**APPLICATION NO. A/NE-TK/837 FOR PERMISSION
UNDER SECTION 16 OF THE TOWN PLANNING ORDINANCE**

Annex 1 - Response to Comments Table

Section 16 Application for Temporary Public Vehicle Park (Private Cars Only) with Ancillary Electric Vehicle Charging Facilities and Ancillary Solar Panels and Associated Filling of Land for a Period of 3 Years at Lot No. 241 in D.D. 23 at Ting Kok, Tai Po, New Territories

Annex 2 : Indicative Layout Plan

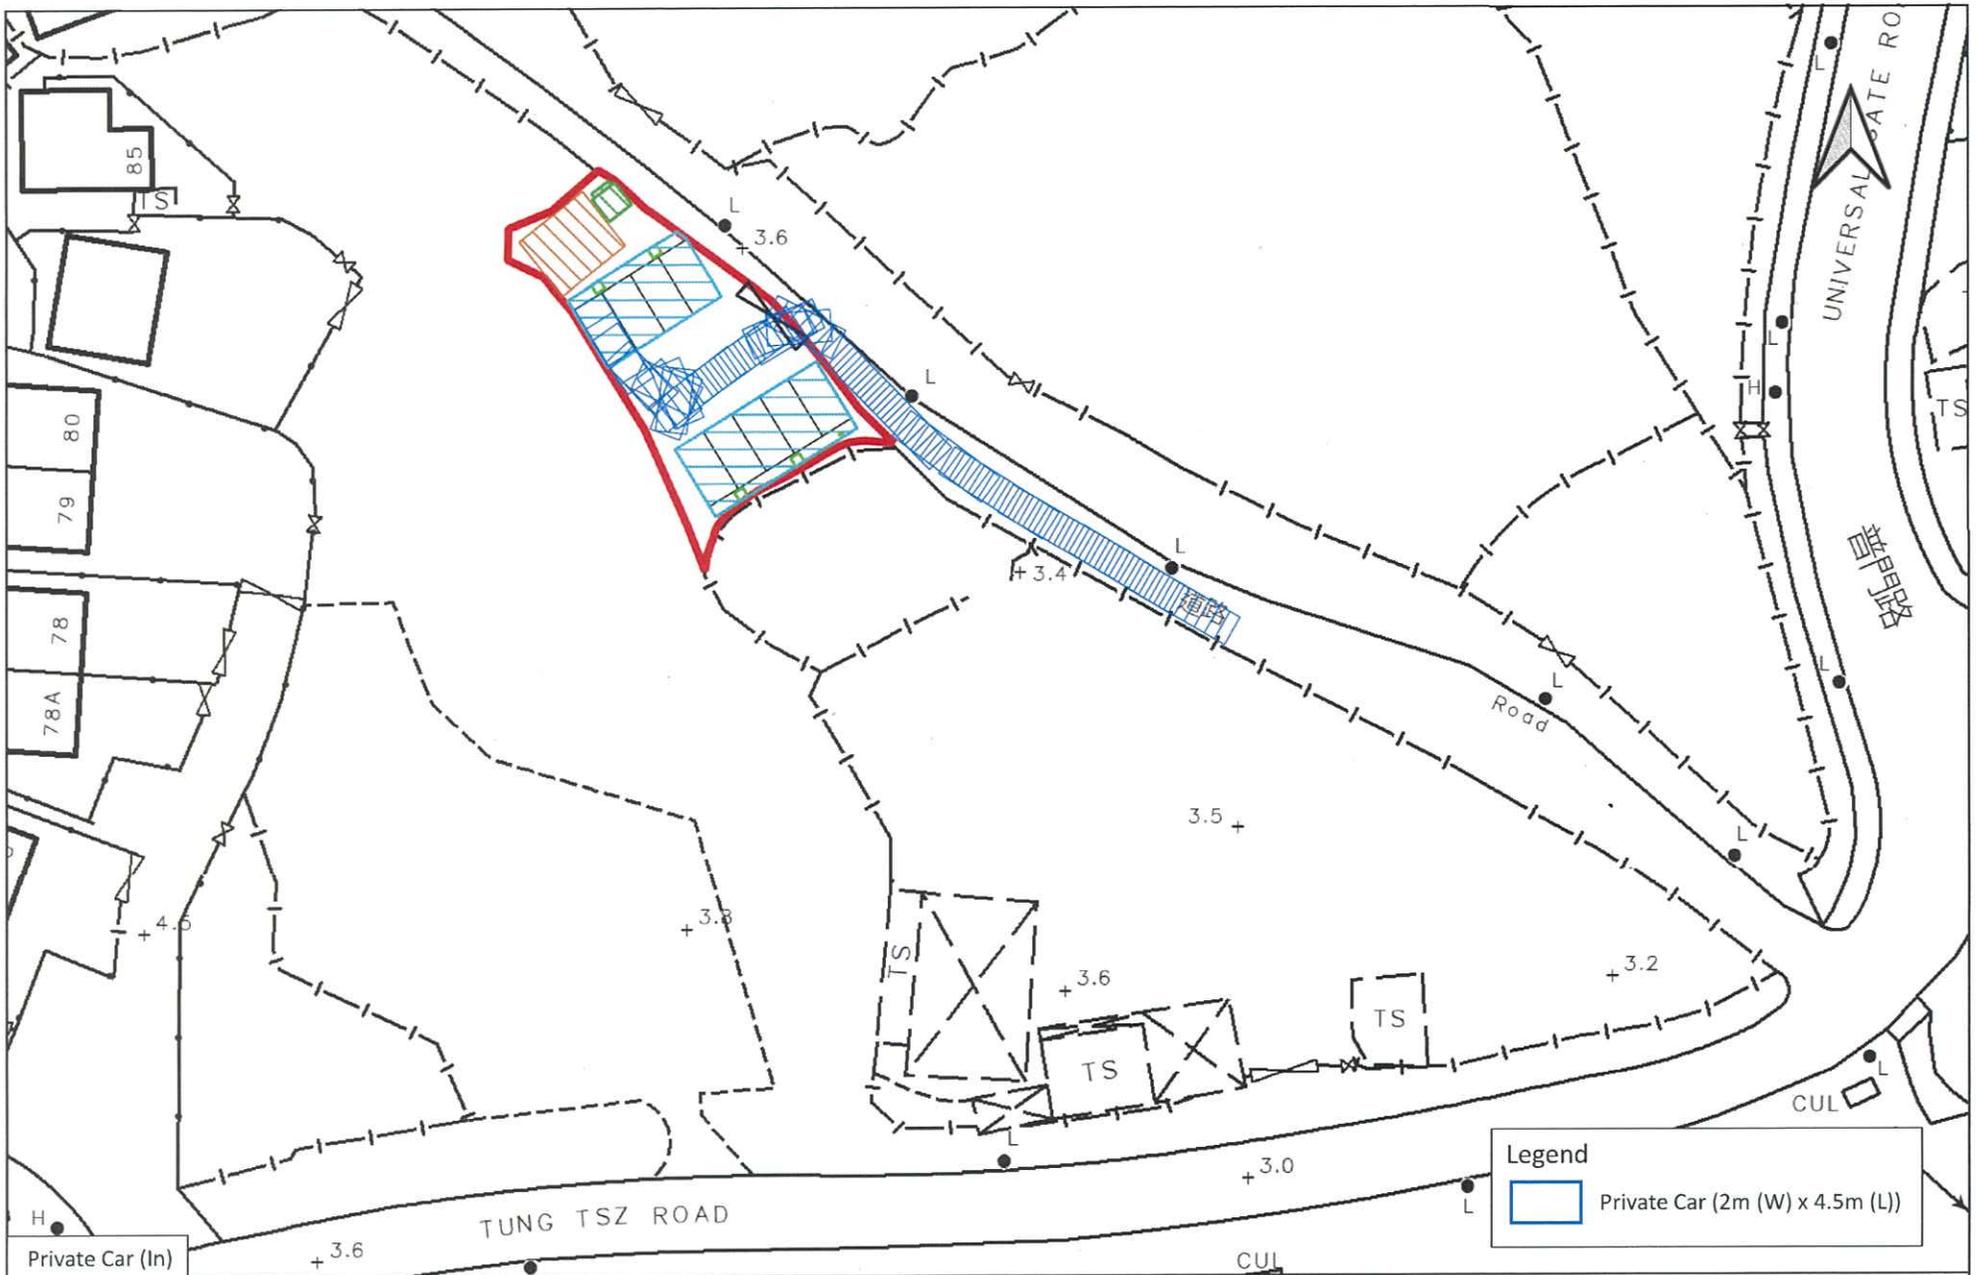
3. Comments from Transport Department received on 25 August 2025		
m	The number of vehicular access for a development site shall be limited to one from traffic management viewpoint. The applicant shall review the number and location of the vehicular access.	Noted, the indicative layout plan in Annex 2 has been revised according to the departmental comment.
n	The applicant shall indicate on plan clearly whether there is boundary fence/wall and demonstrate the maneuvering of vehicles does not clash with the fence/wall. The swept path analyses clashes with both black line and red line on plan which indicates vehicles have to go beyond the proposed 6m wide ingress/egress when entering or leaving the site.	Noted, the indicative layout plan and the corresponding swept path analysis in Annexes 2 and 4 have been revised to reflect departmental comment. There will be bollards instead of fences to define the site boundary and entrance, ensuring no conflicts with fences or walls during vehicle entry or exit. The swept path analysis is provided for indicative purposes only.

Annex 4 : Swept Path Analysis

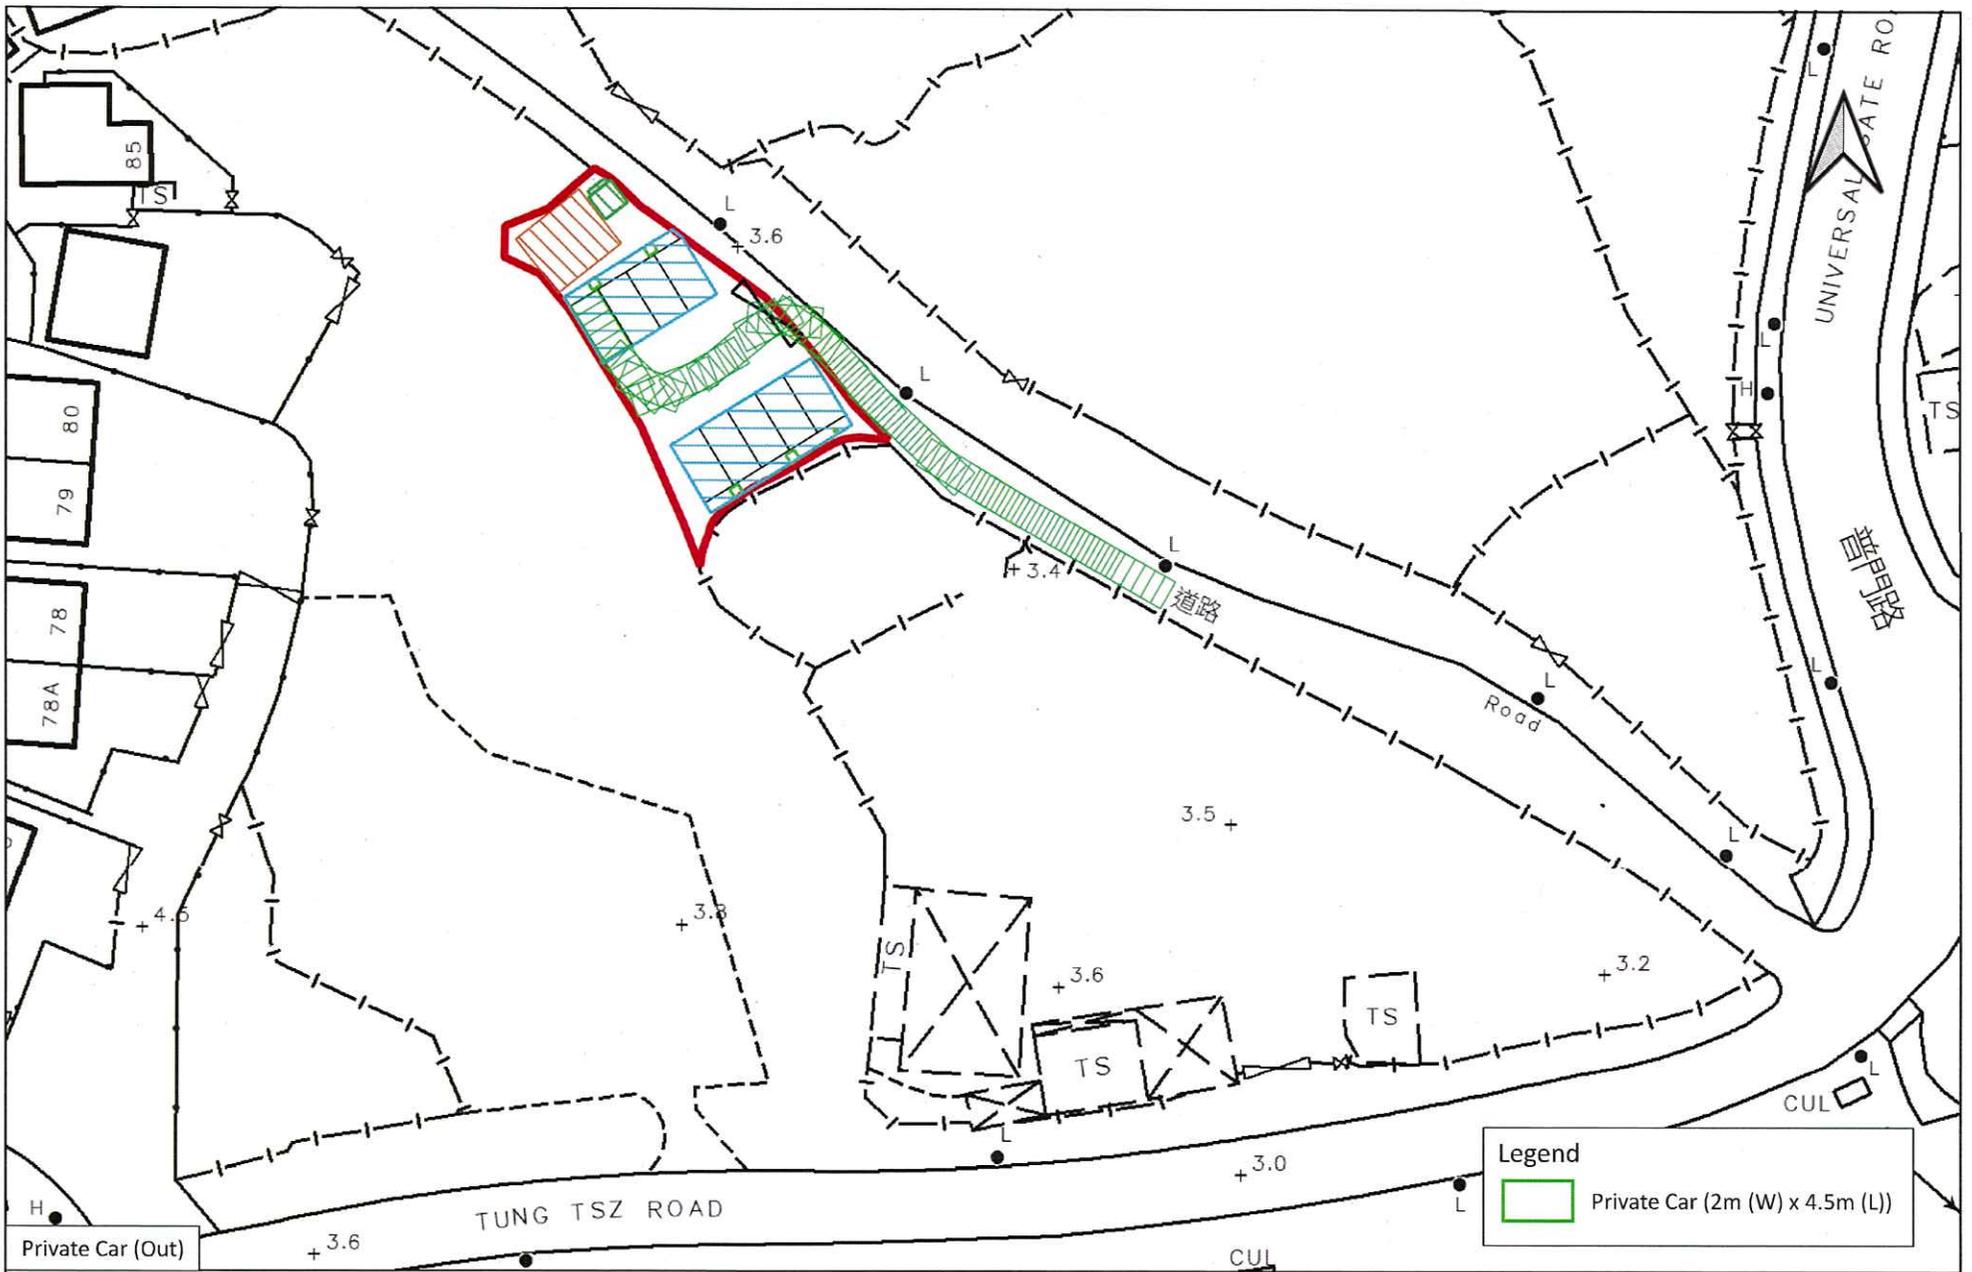
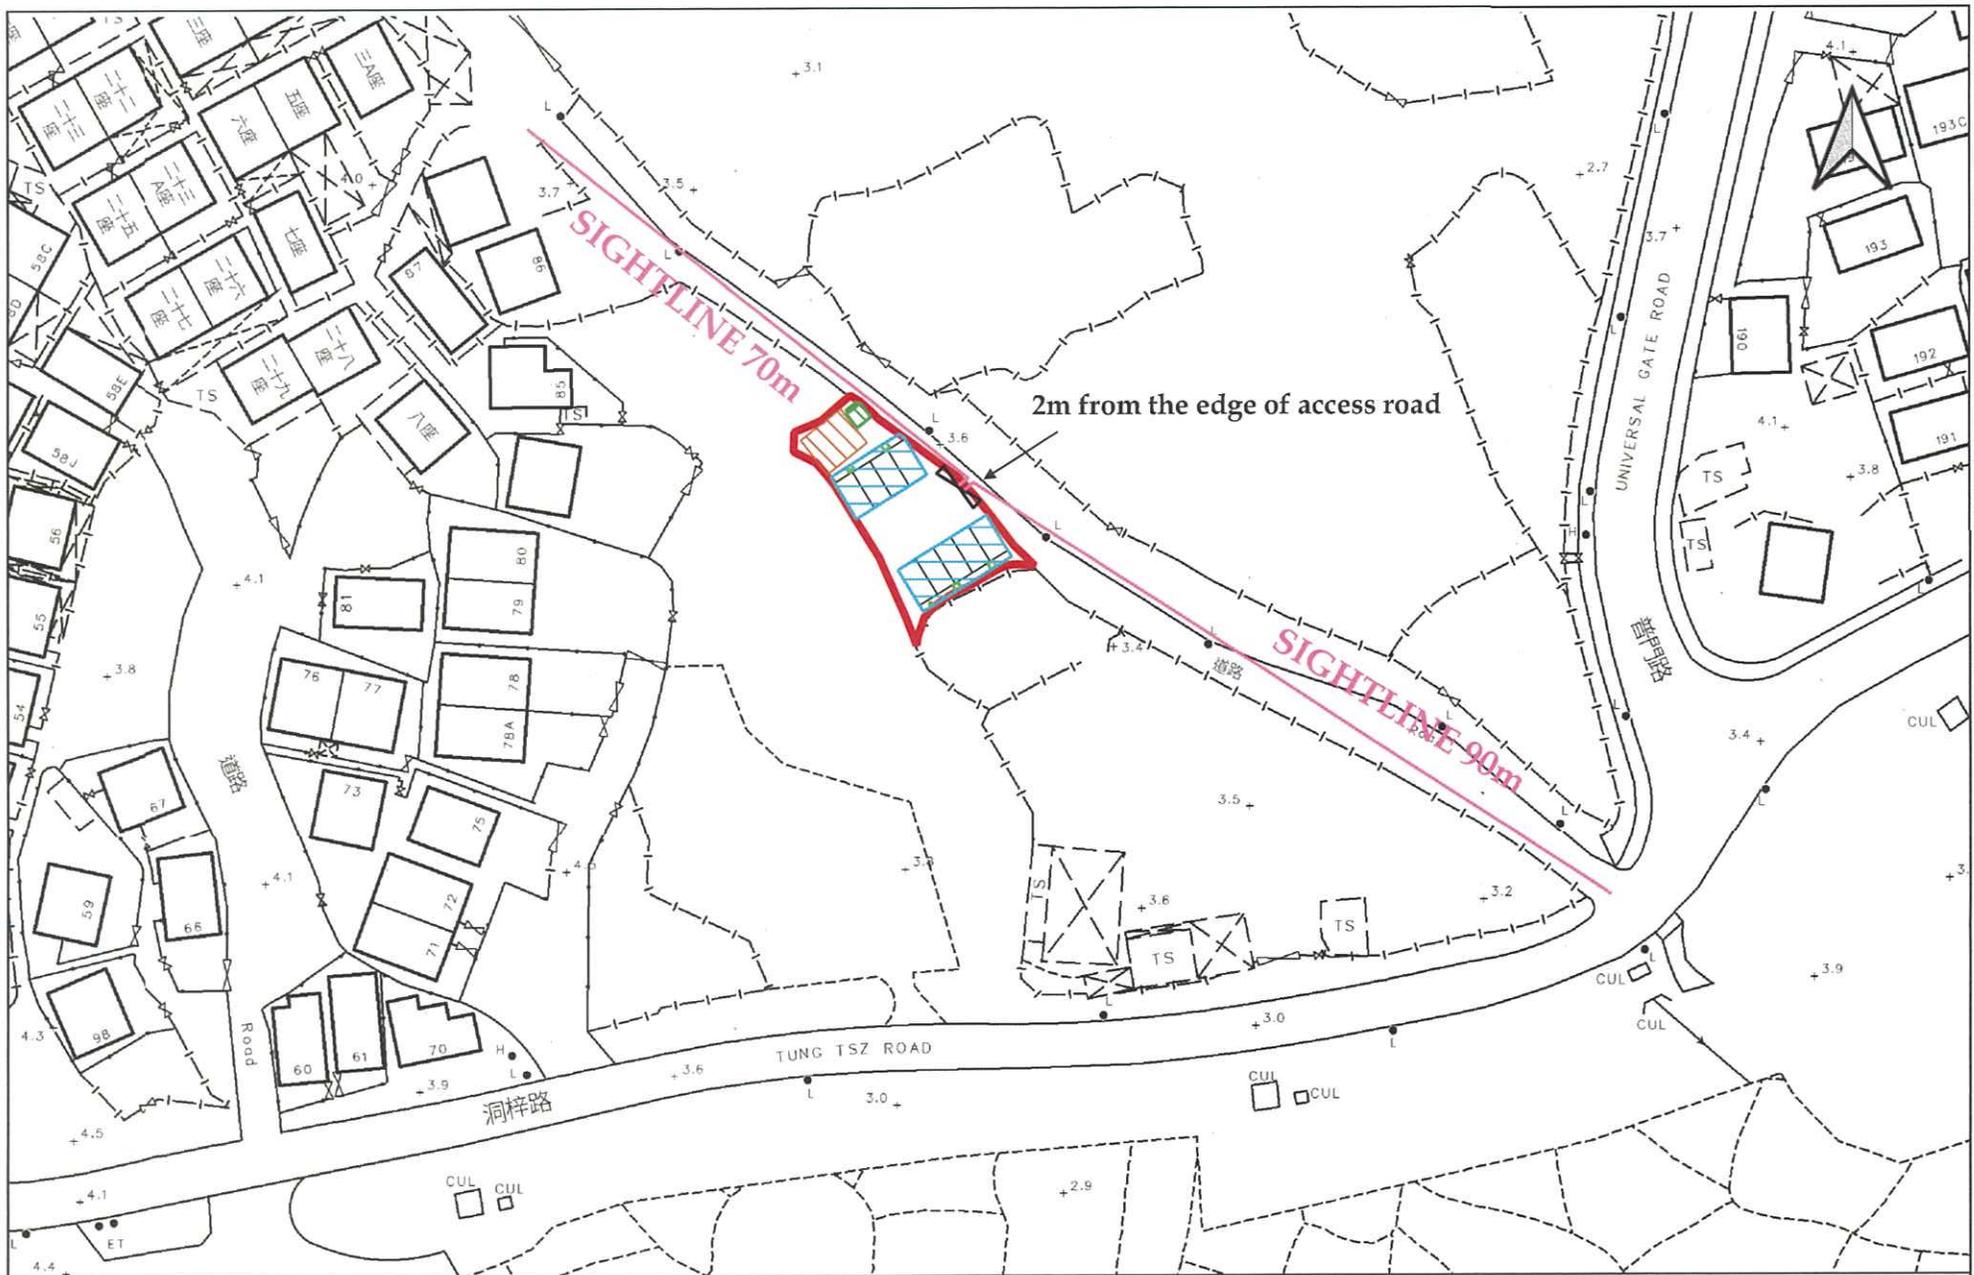
o	There are limited maneuvering spaces within the site and the adjacent local access, swept path analyses for the vehicles at other parking spaces shall be provided to demonstrate the practicability.	The indicative layout plan and the corresponding swept path analysis in Annexes 2 and 4 have been revised, demonstrating that there will be sufficient space for maneuvering within the site and the adjacent local access.
p	The swept path analyses reveals that reverse steering is required to park the vehicles, the applicant shall review and propose management measure to reduce the risk due to frequent reverse steering on the local access and within the site.	Noted, the revised swept path analysis in Annex 4 has demonstrated that there will be sufficient space for reverse steering manoeuvres within the site. To further mitigate associated risks, management measures such as the provision of highly visible signage and ground markings will guide drivers during reverse steering. In addition, regular monitoring and reviews will be

Annex 5 : Sightline Analysis

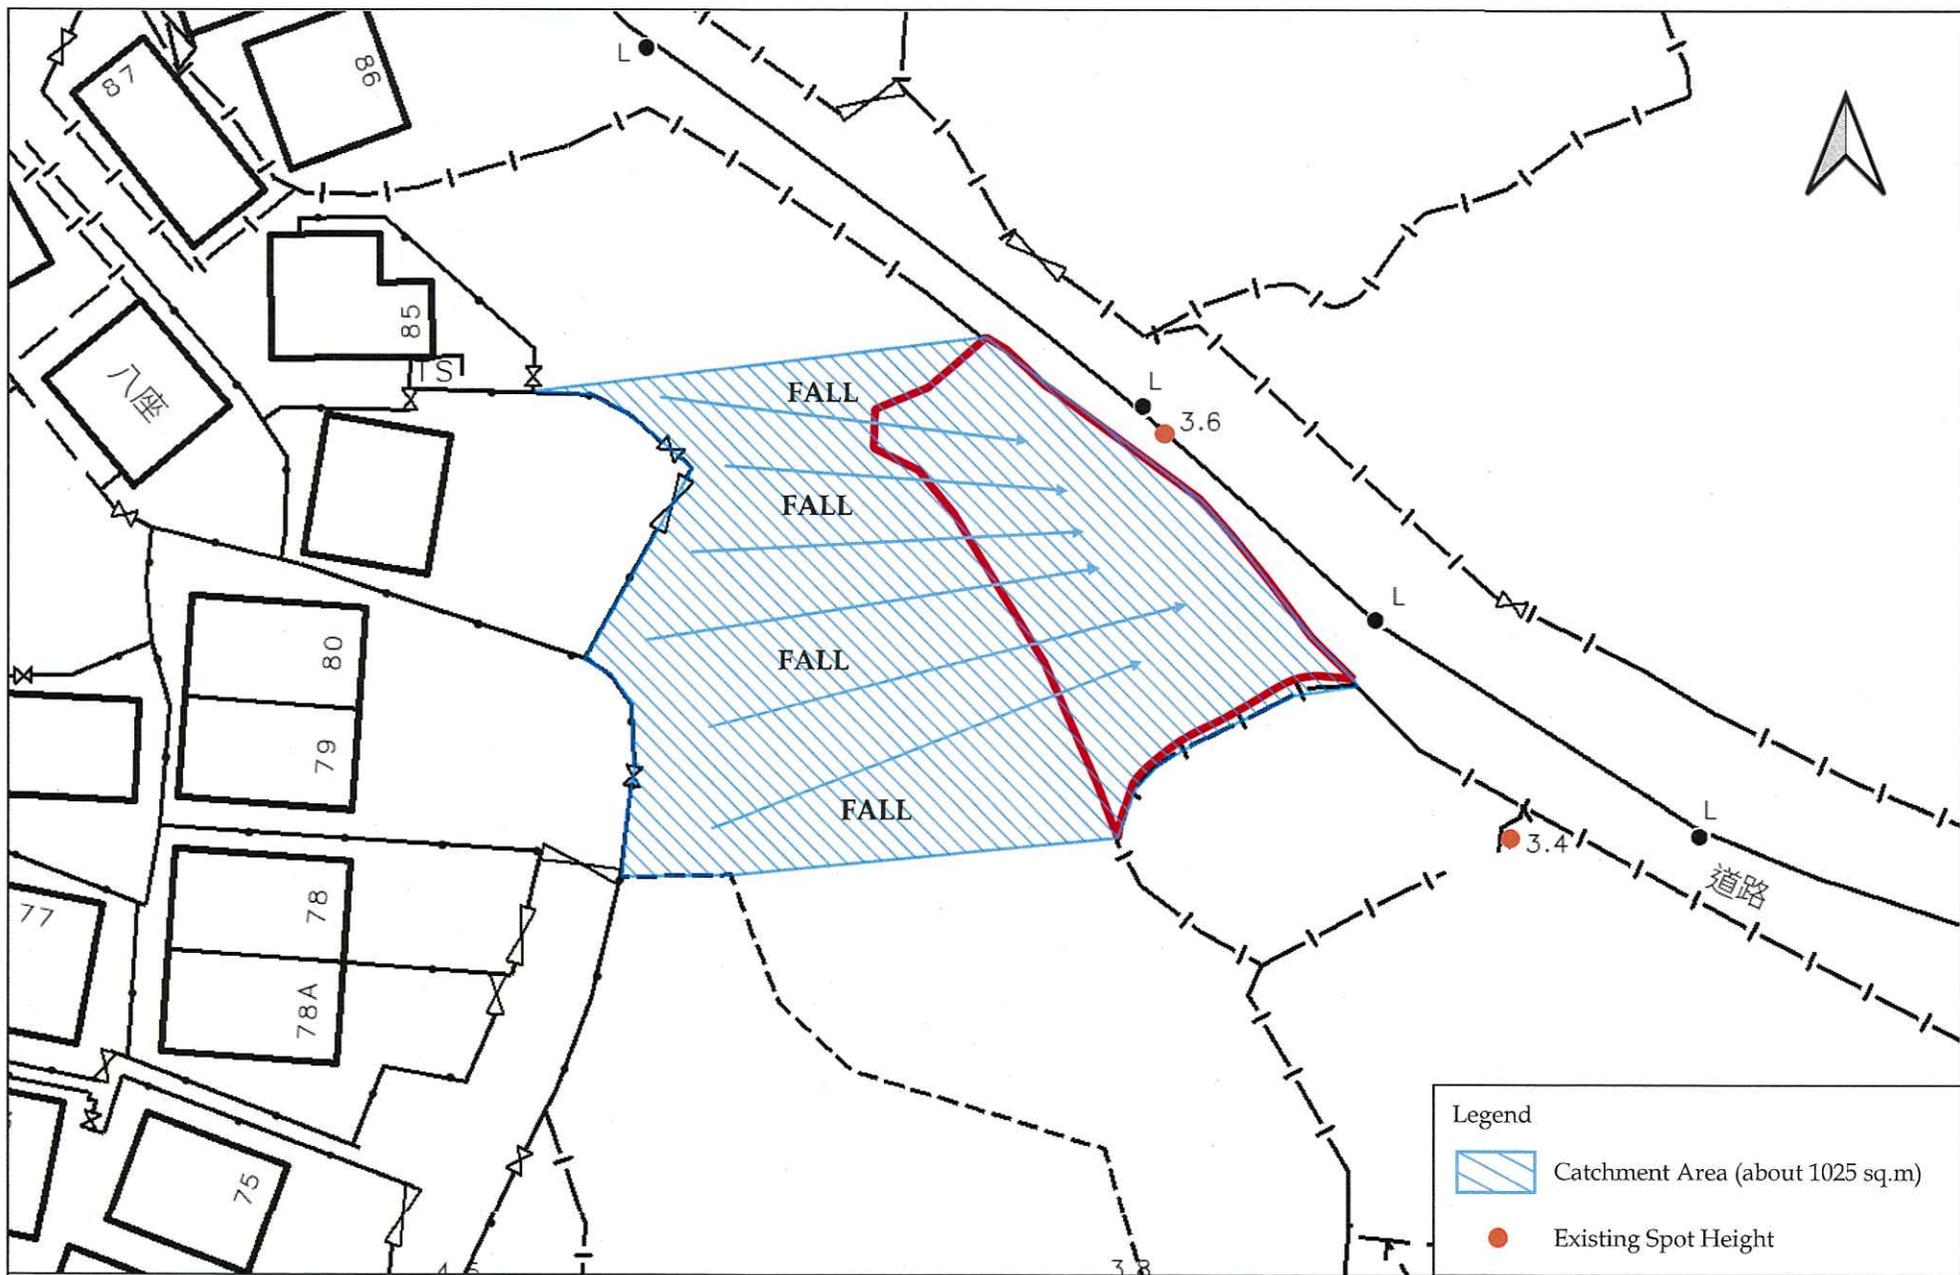
conducted to identify and address any emerging safety concerns during the operation of the proposed vehicle park.
q	The sightline assessment shall be conducted at a point 2m from the edge of access road and the sightline shall cover the entire section of access road.	Noted, the sightline analysis in Annex 5 have been revised according to the departmental comment.
r	All plans shall be in scale.	Noted.
